L634-
A.01.26

To: After Sales Official Network
Subject: Rework routing RH VVT cable
Date: 16/01/2026
Pages: 6

Campaign name:
Rework routing RH VVT cable

Model:
Temerario

OPERATION B (Only for standard version):

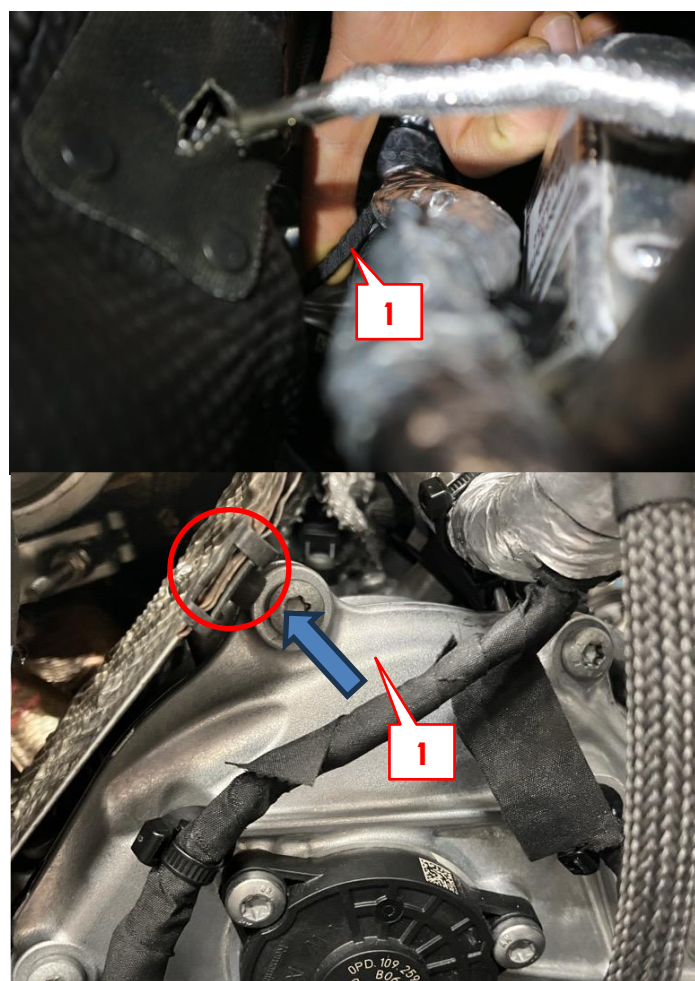
1. Open the right kidney.
2. Locate the wiring (1) (right side of the motor).

3. Push the wiring (1) upwards from the bottom towards the screw/clip (circled) on the heat shield and check whether the wiring (1) comes into contact with the screw/clip.
4. If the wiring (1) does not make contact, push the wiring (1) down again, moving it as far away as possible from the screw/clip. The check can then be considered complete.
5. Close the right kidney.
6. If the wiring (1) makes contact, perform **operation D**.

OPERATION C (Only for lightened version):

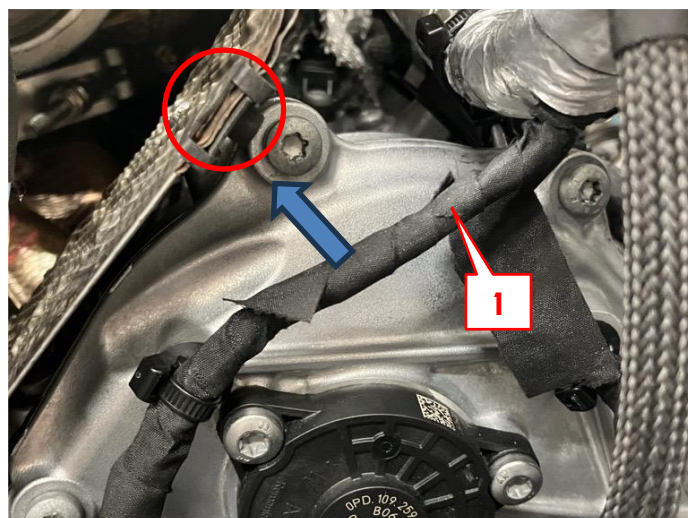
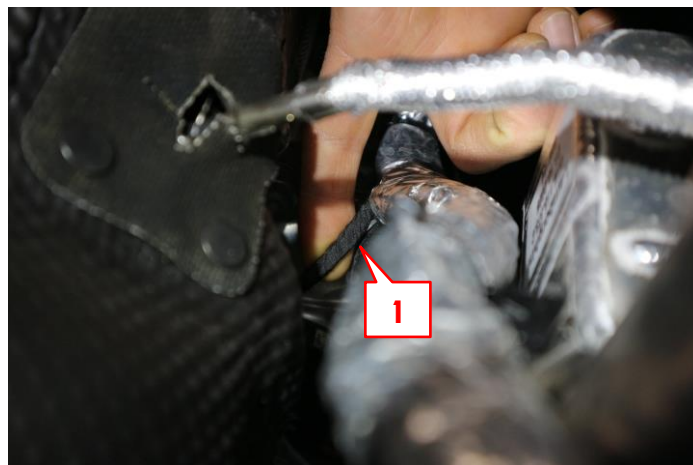
8. Locate the wiring (1) (right side of the motor)

9. Push the wiring (1) upwards from the bottom towards the screw/clip (circled) on the heat shield and check whether the wiring (1) comes into contact with the screw/clip.

10. If the wiring (1) does not make contact, push the wiring (1) down again, moving it as far away as possible from the screw/clip. The check can then be considered complete, follow the instructions given in the Workshop Manual at the following path:

11. If the wiring (1) makes contact, perform **operation E**.

OPERATION D (Only for standard version):

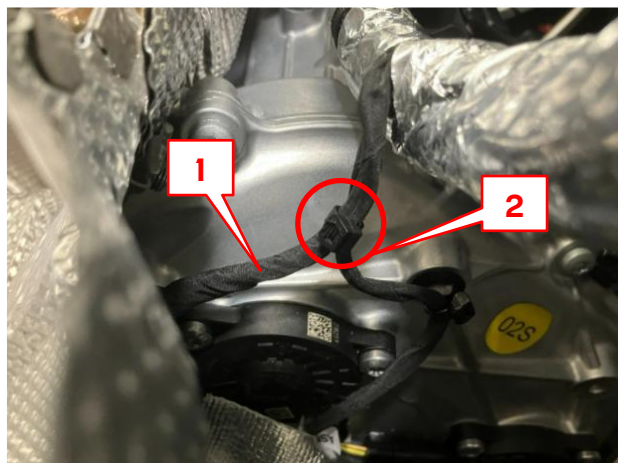
12. Check that the wiring (1) is not damaged due to contact with the screw/clip on the heat shield.
13. If the wiring (1) is intact and undamaged, add the cable tie (N90937701) by attaching it to the second wiring (2) of the GDI pump. After applying the cable tie, check that the wiring (1) does not touch the screw/clip.

14. If the wiring (1) has suffered any kind of damage, open a claim on the Liass portal.
